Valhalla Gas Exploration and Appraisal Program Select RFI Responses by INTERA Geosciences Pty Ltd

Original items are in blue; responses are in black.

Figure 17-2. Modelled drawdowns for the Liveringa as presented in the original model report. The drawdown contours with the greatest radius around each bore is 0.1 m. A closeup of the area around the “Mus” (Muspelheim) bore is shown in Figure 17-3

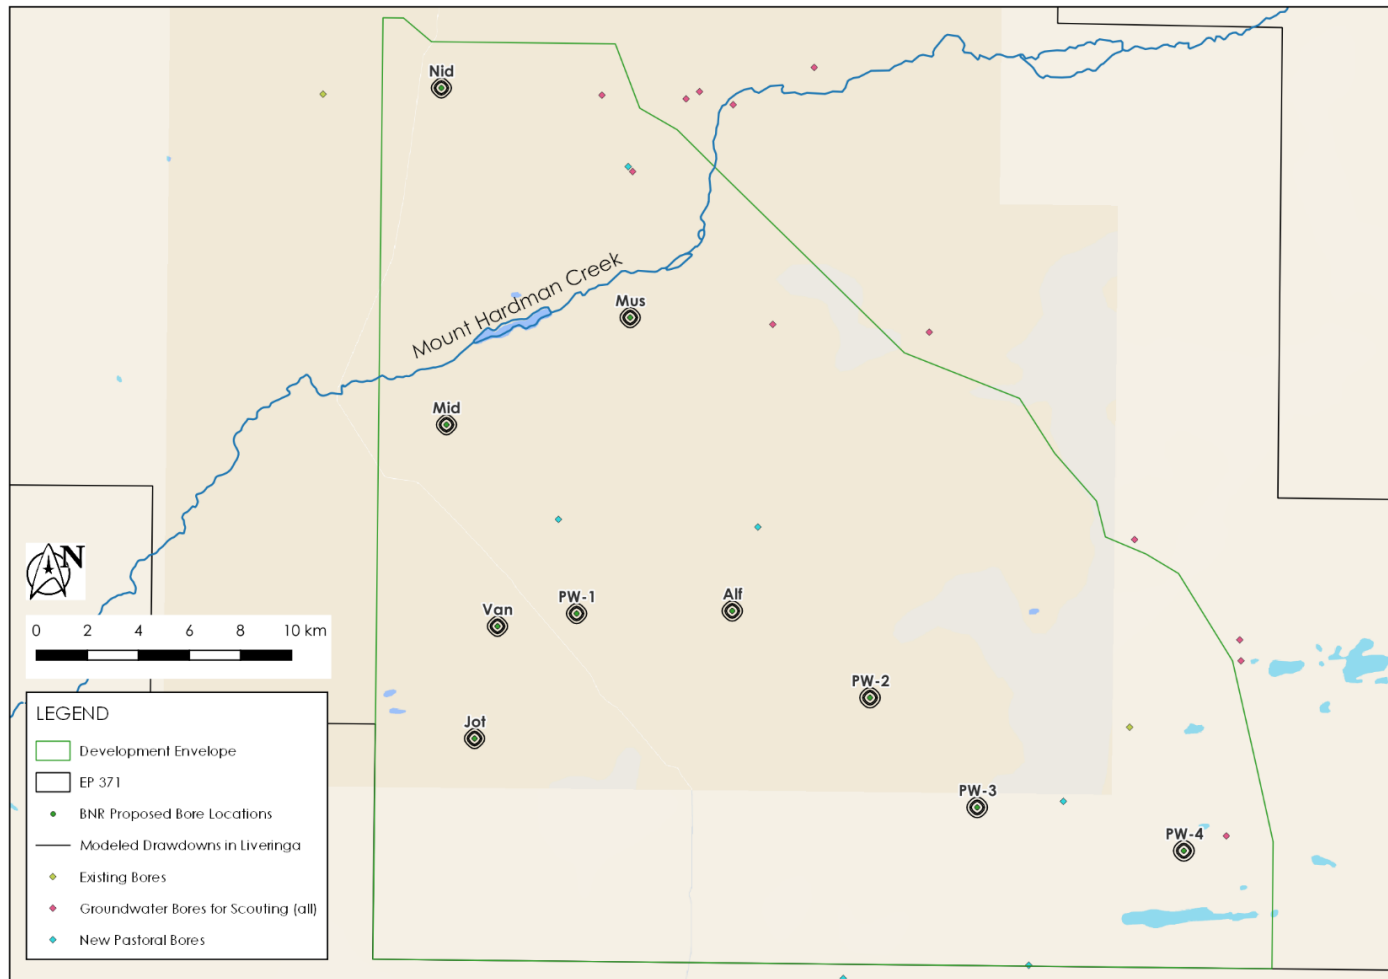
- Simulated Liveringa drawdowns presented in the original model indicated very localized drawdowns with a 0.1 m drawdown contour about 400 meters from each individual bore (see **Figure 17-2**). As indicated by Figure 5-3(a) in the original model report, model-calculated drawdowns are less than 1 mm at 700 m from each abstraction bore location. Given that data from bores in the study area as presented in Appendix J of the Valhalla ERD show variations of greater than a meter over the period of record, a modelled variation of 1 mm is a negligible value, which in turn indicates that modelled drawdowns are essentially zero outside of 500-600 m from each bore.

- The implication of the original model results is that with all ten water supply bores pumping at the same time any drawdown to the Liveringa greater than 0.1 m is restricted to a radius of 400 m from each bore. The nearest known GDE (Mount Hardman Creek) to any of the BNR proposed bore sites is approximately 1 km from the Muspelheim site and is therefore well out of the modelled zone of drawdown influence (**Figure 17-3**).

Figure 17-4. Locations of pilot points used in the UA for the Liveringa Aquifer drawdown model.

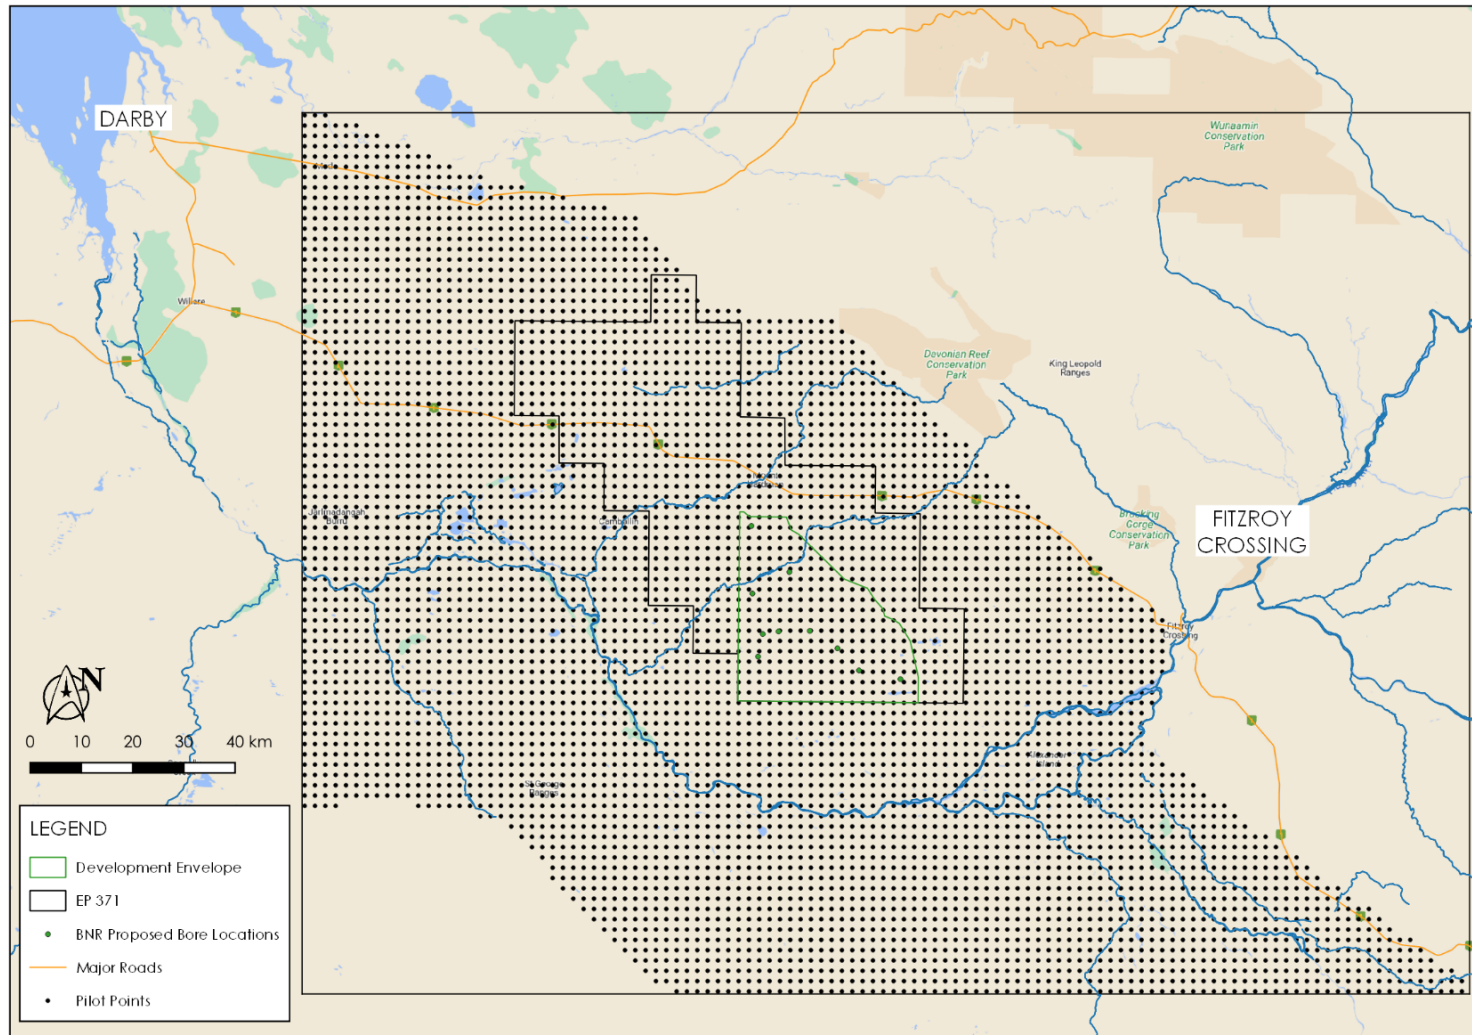
Figure 17-4 shows the distribution of pilot points relative to the model grid. For each parameter type (K, Ss, Sy), 200 realisations of pilot point parameter values were drawn using Monte Carlo sampling from multivariate Gaussian distributions with the above ranges assumed to represent four standard deviations (in \log_{10} -space) and with spatial correlations described by an

Figure 17-5. Map showing the distribution of probabilities that drawdowns will exceed 0.1 m at the end of the 6-month abstraction period.

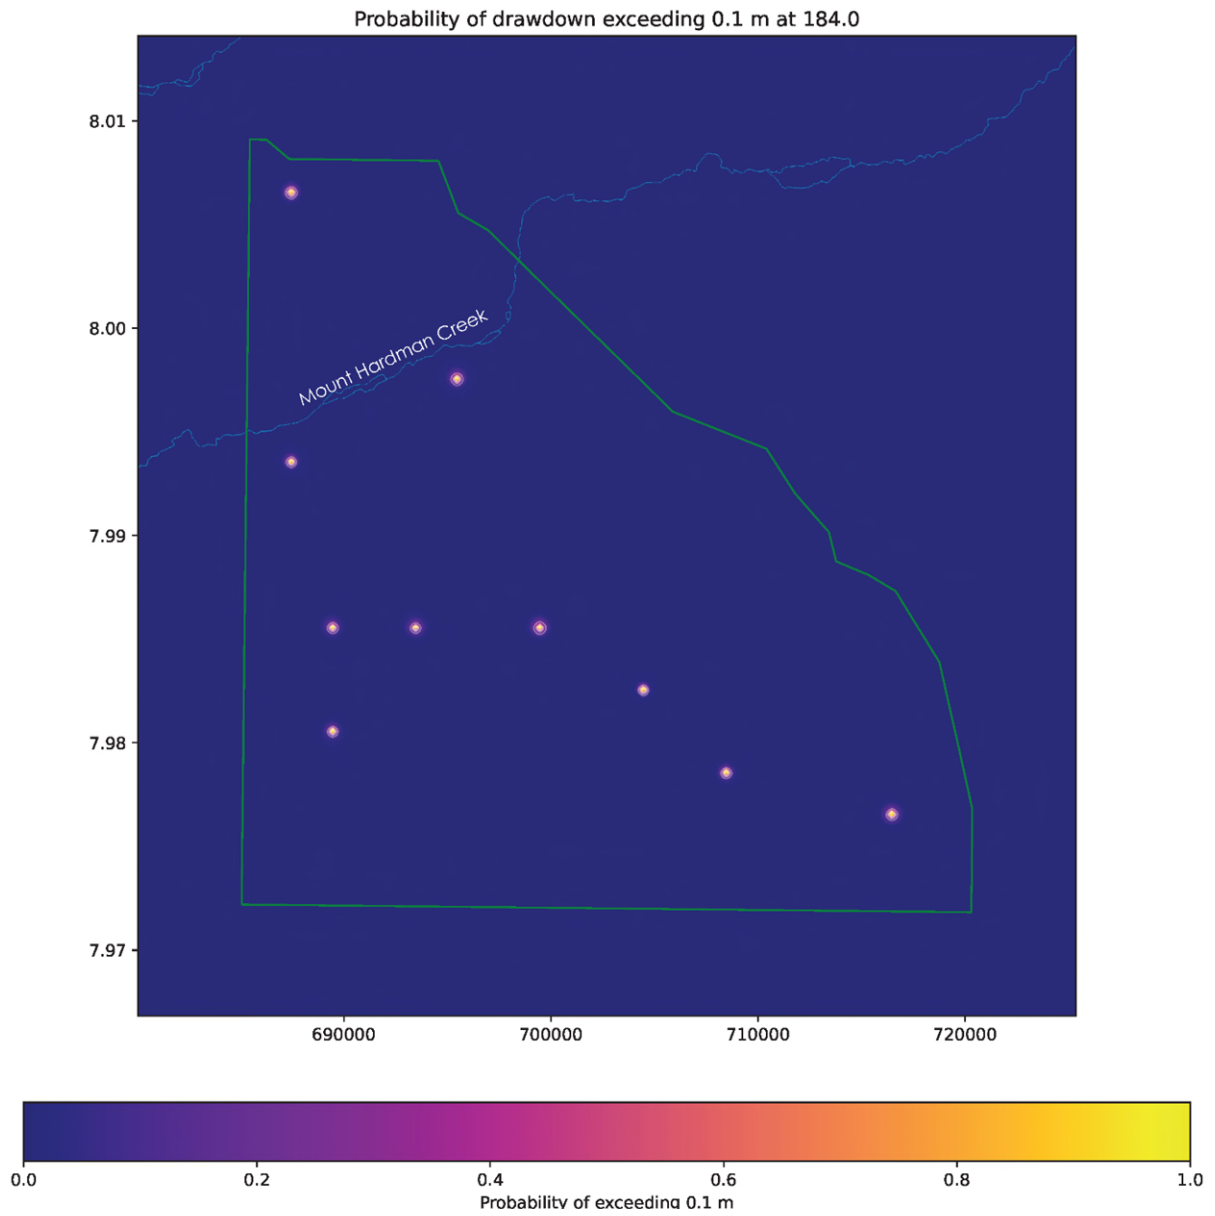
To address the requirements of Item 17(b) a stochastic uncertainty analysis was undertaken for the Liveringa model. The uncertainty analysis propagates prior uncertainty of model parameters through the numerical model to provide a prior definition of model output (e.g. drawdown) uncertainty. Parameter uncertainty was expressed at each of 5,412 geostatistically correlated pilot points with 2 km spacing and reflecting the following prior parameter ranges:

exponential variogram with an effective range of 18 km. Pilot points were interpolated to provide 200 realisations of model input parameter fields for K, Ss, and Sy. Each parameter realisation was simulated using the numerical model to produce 200 realisations of drawdown. From these, exceedance probability maps were calculated. The map showing the exceedance probability distribution for 0.1 m of drawdown at the end of the 6-month pumping period is shown in **Figure 17-5**. As indicated by Figure 17-5, the areas of the model domain with a non-zero probability of drawdowns exceeding 0.1 m are constrained to within a radius of about 500 m around each of the proposed abstraction bores. **Figure 17-6** shows that radius compared to the modelled drawdowns from the original model as shown in Figures 17-2 and 17-3. As expected, the UA with 200 realizations that incorporate the full prior parameter ranges results in a radius for the 0.1 m drawdown contour that is greater than the contour using a single "average" or "typical" value; however, the radius indicates that the area with a non-zero probability of exceeding 0.1 m is at least 1 km from the nearest GDE.

Figure 17-6. Modelled Liveringa Aquifer drawdowns at the proposed Muspelheim abstraction bore as presented in the original model report compared to the radius of the zone with a non-zero probability of drawdowns exceeding 0.1 m. Modelled drawdowns are in meters.

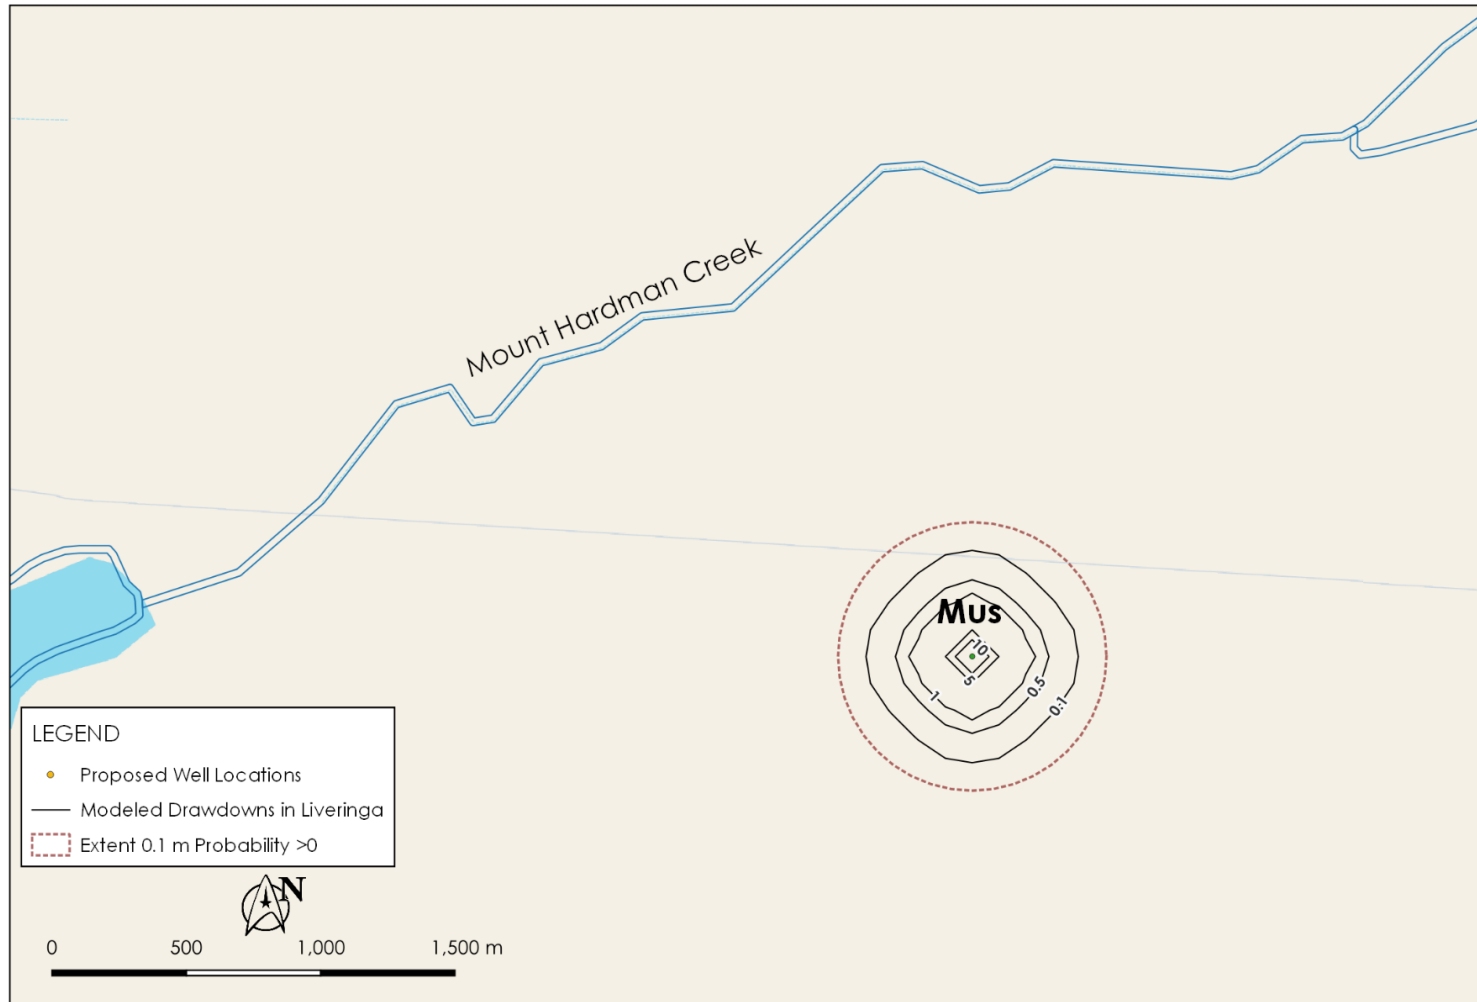
b) Provide justification, with supporting evidence, for the assessment of limited impacts to the Mount Hardman creek, a groundwater dependent ecosystem.

The response to Item 17(b) provides a UA-based modelling evaluation that follows the standards presented in the requirements for applying UA to models supporting proposed CSG or LCM developments. The modelling results provide a distribution of probabilities which show that the areas within the project area with a probability of impact from the abstraction bores is limited to a restricted zone around each proposed abstraction bore. The results of the UA modelling also indicate that Mount Hardman Creek at its nearest location is at least 1 km from the edge of the modelled zone with a non-zero probability of experiencing a drawdown greater than 0.1 m (see Figure 17-6).
